Seismic Walkdown Checklist (SWC)

Equipment ID No. I-1605-95-SPB Equip. Class¹² ZO

Equipment Description SOLID STATE PROT SYS CAR-TEN B

Location: Bldg. CONTROL Floor El. 220 Room, Area 165

Equipment ID No. 1-1605-Q5-SPE Equip. Class¹² 20

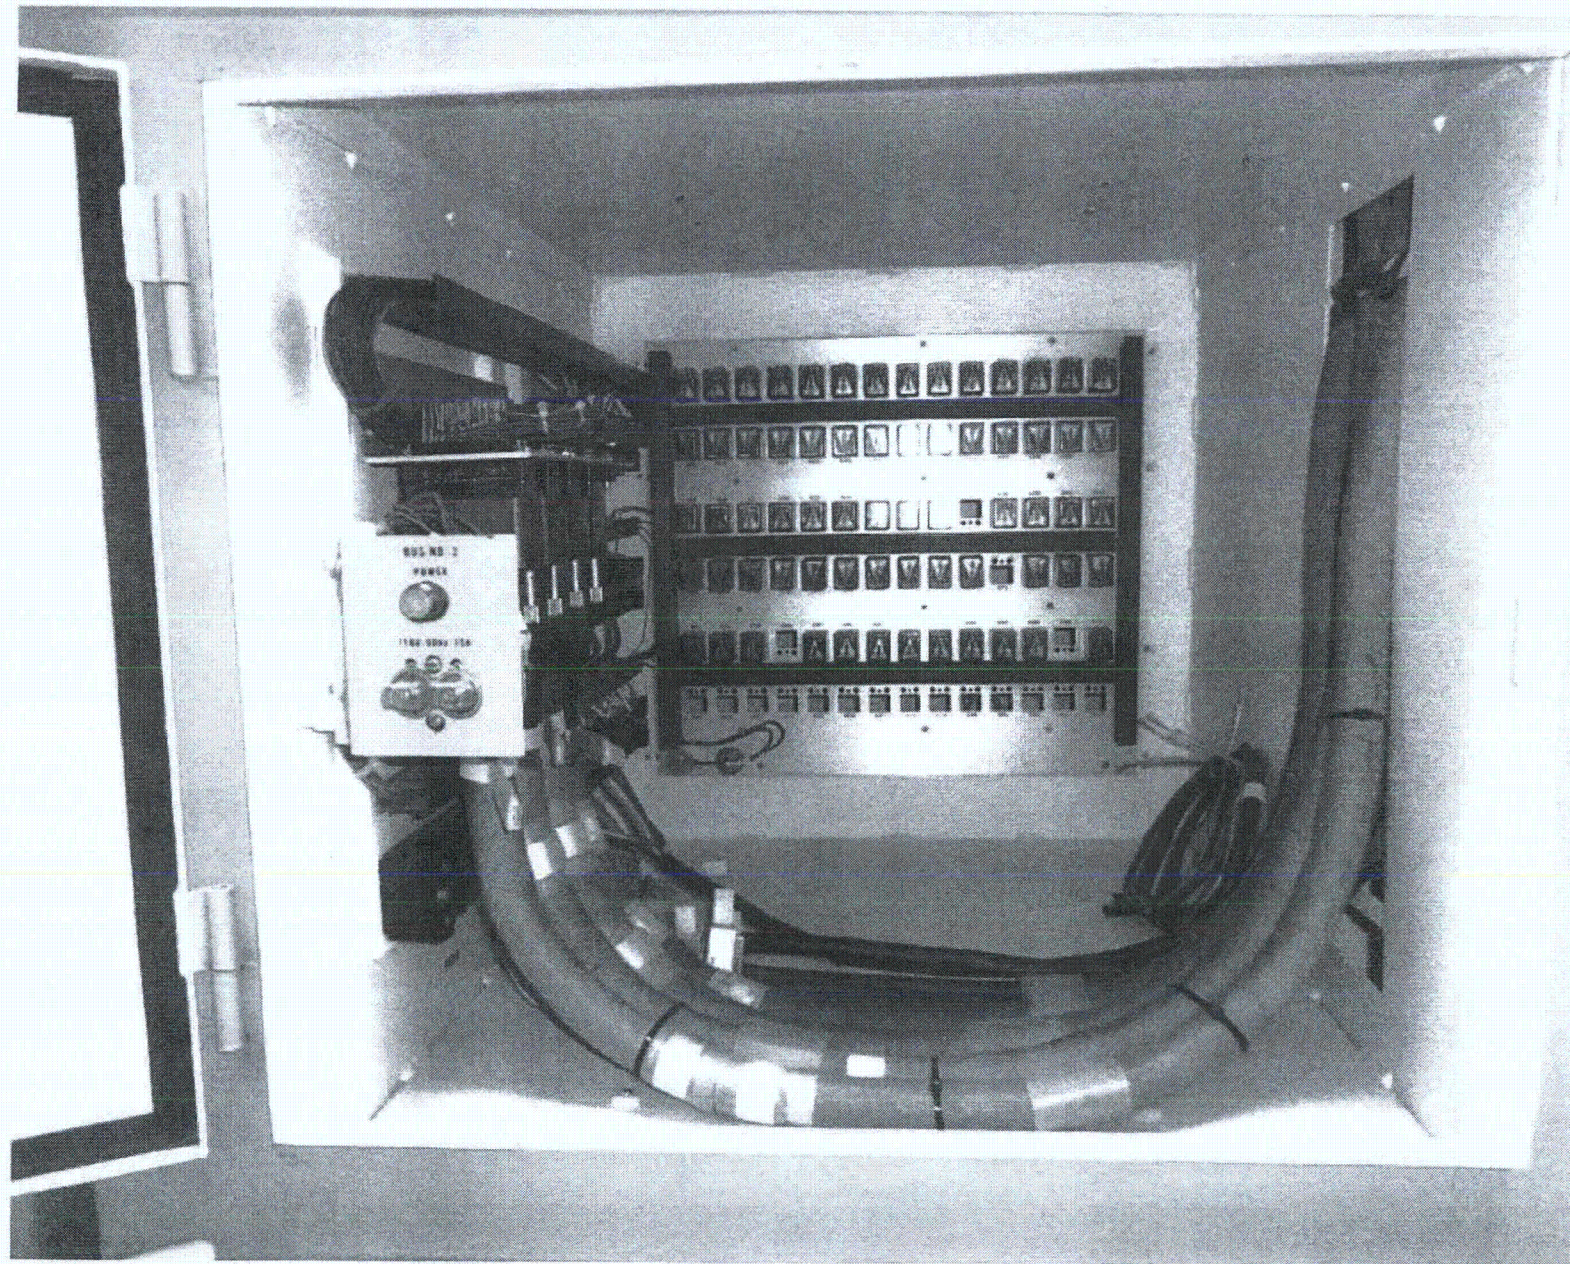
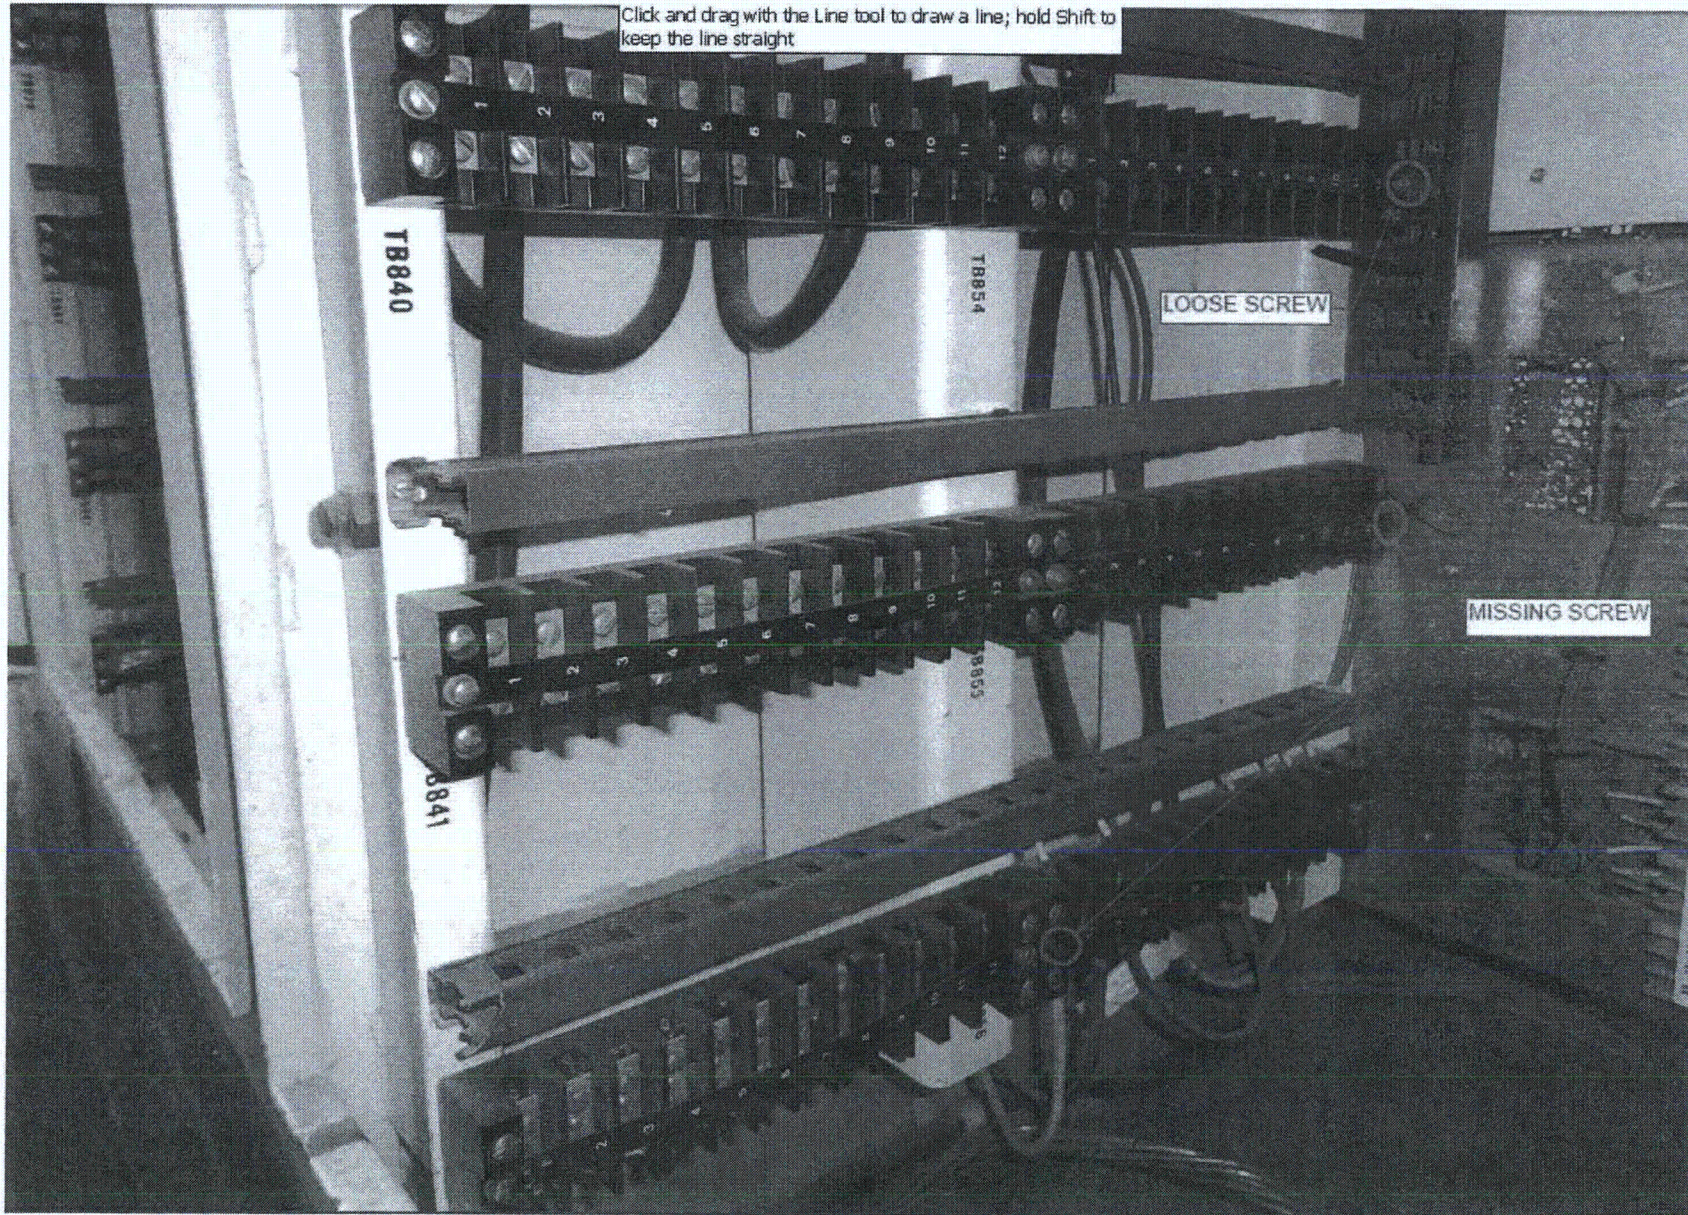
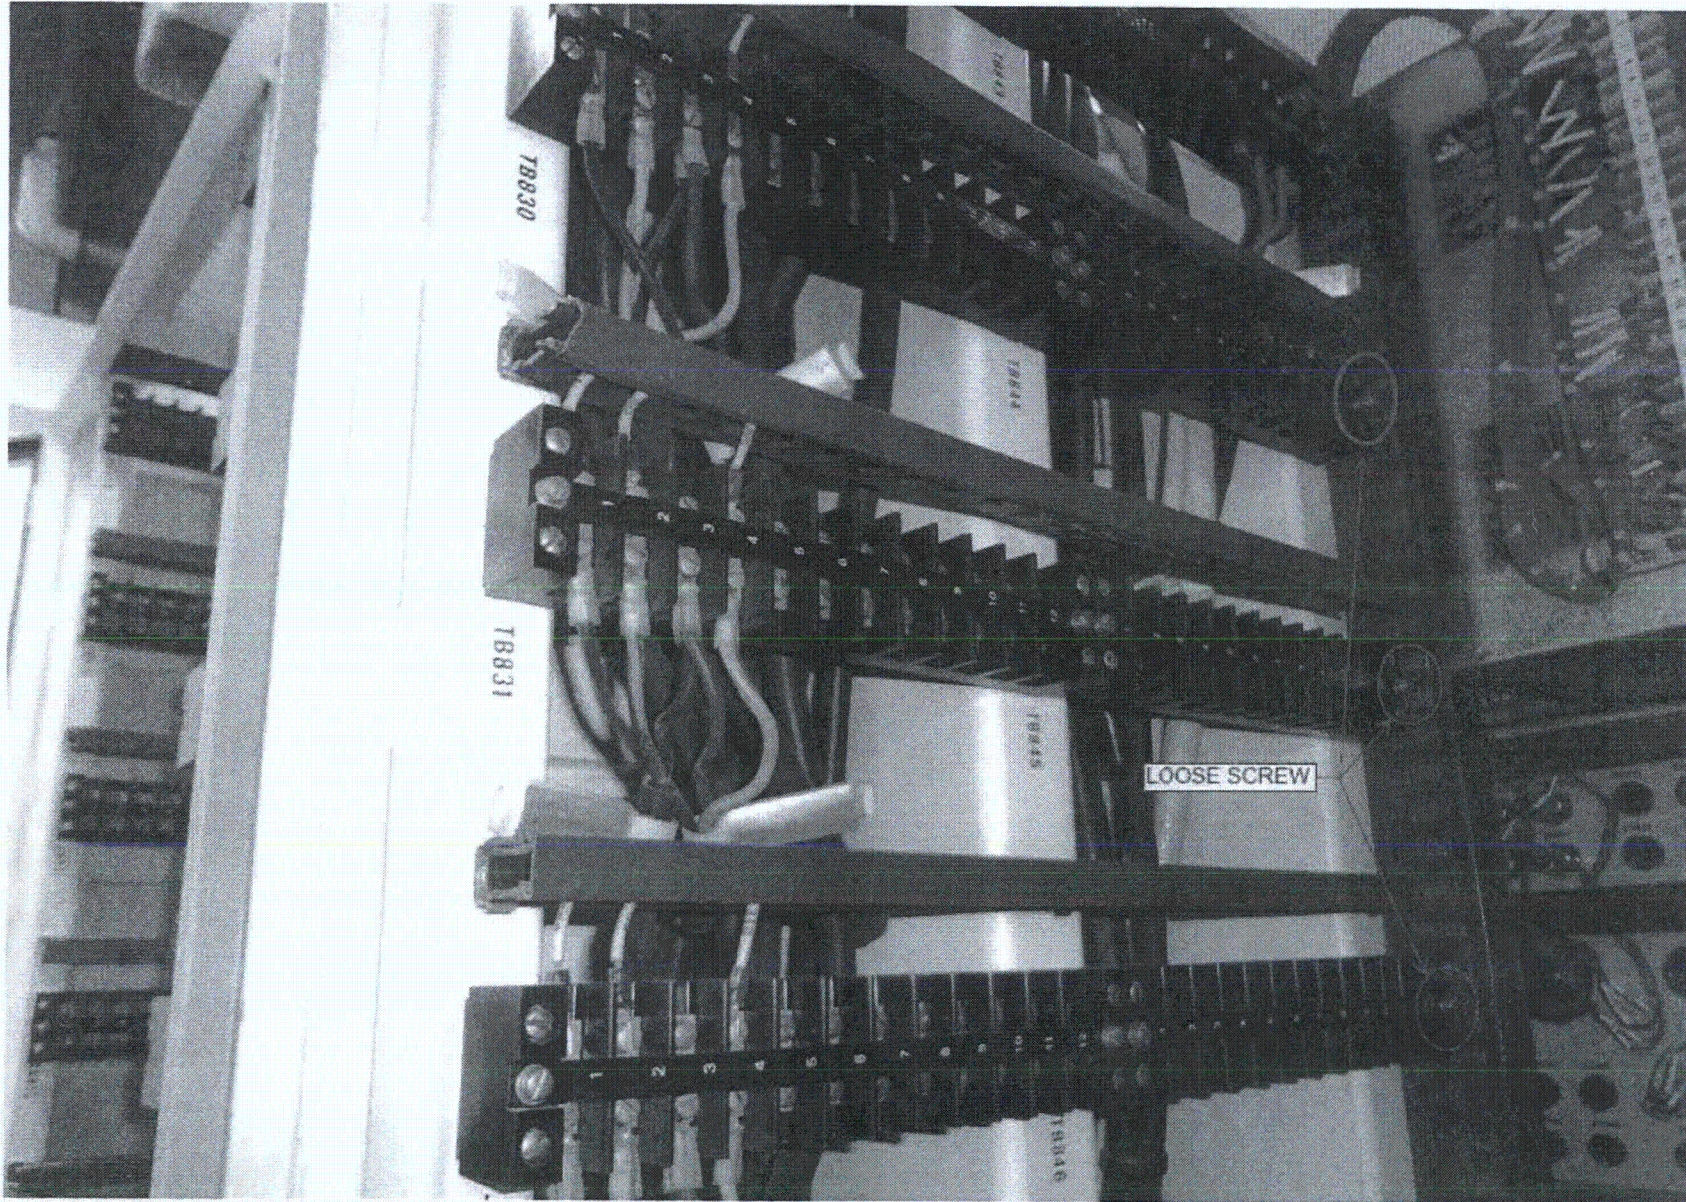
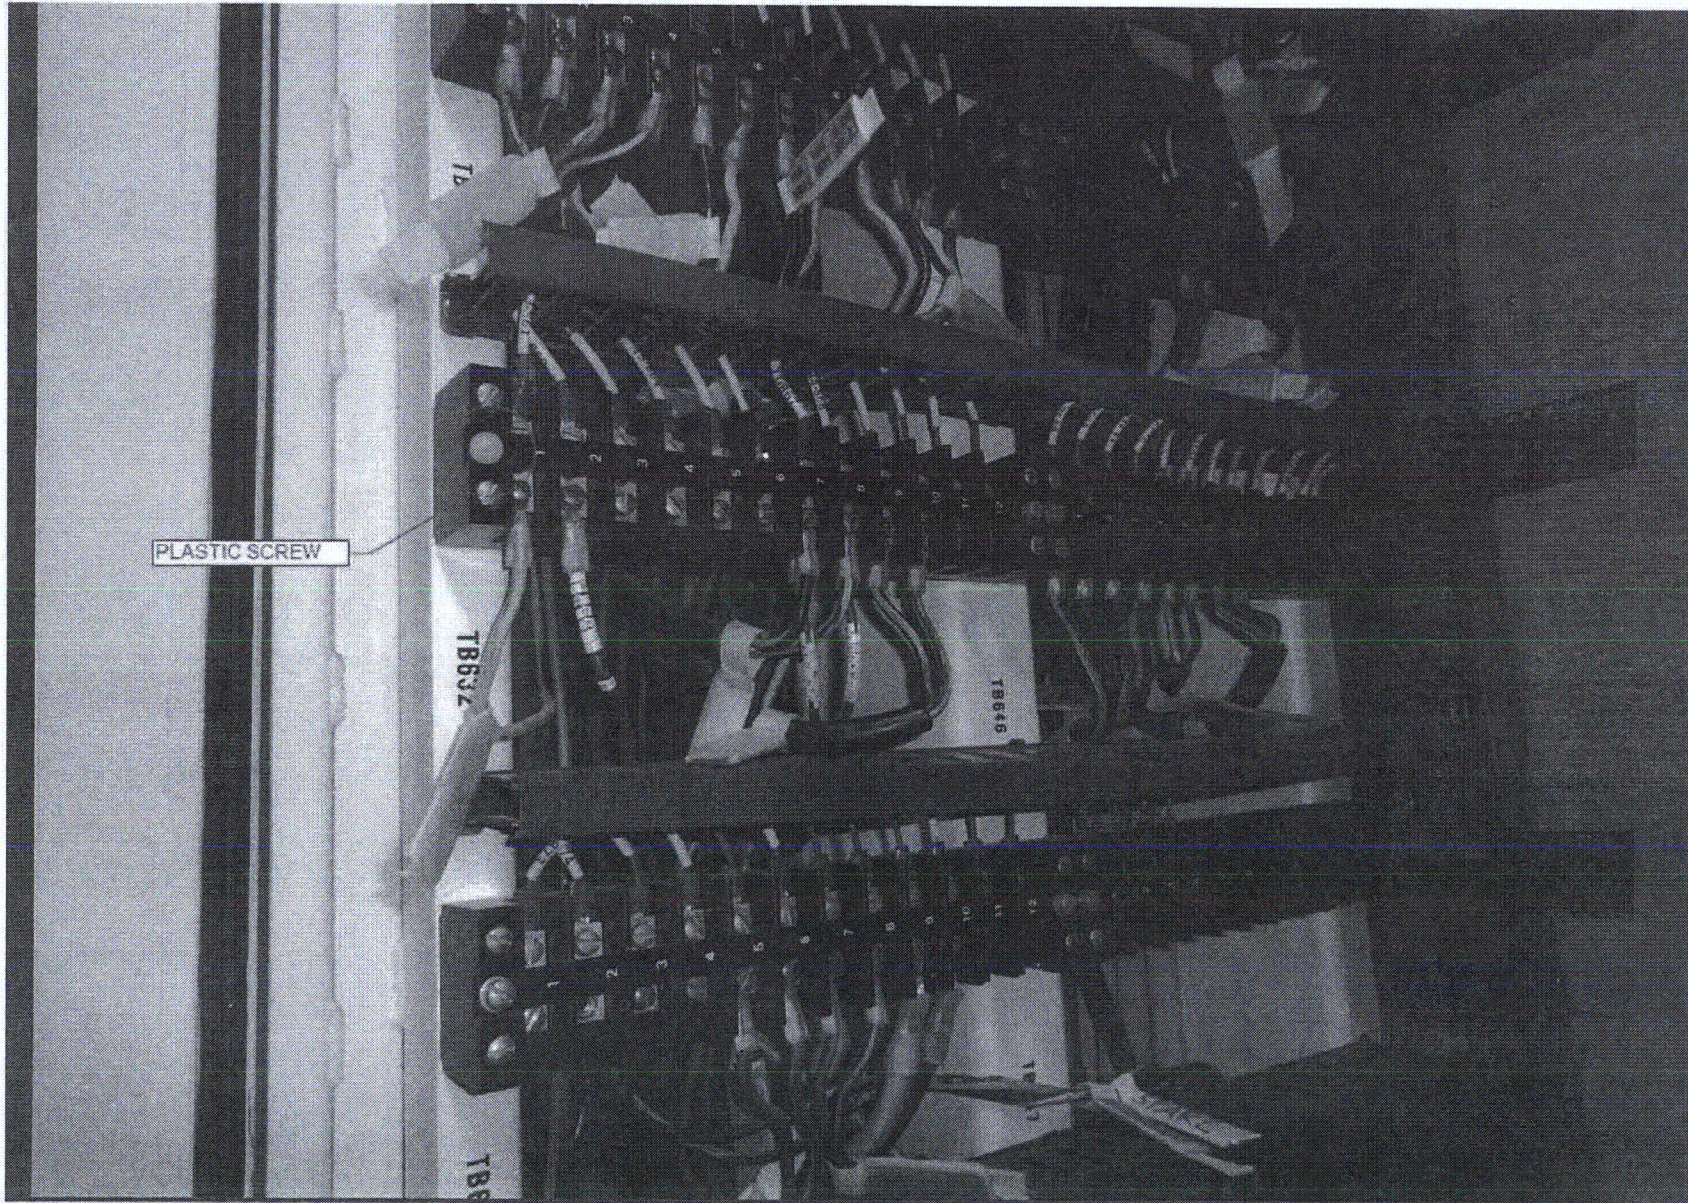
FOUND MISSING 1/2 LOOSE SCREWS USED TO SECURE PROTECTIVE COVERS, TERMINAL BLOCKS, 1/2 ALSO A CRACKED CABLE TRAY INSIDE THE CABINET. THE SEISMIC WALKDOWN TEAM JUDGED THAT THIS CONDITION DOES NOT REPRESENT A SEISMIC OR OPERABILITY CONCERN. THESE CONDITIONS WERE REPORTED UNDER CR 527627
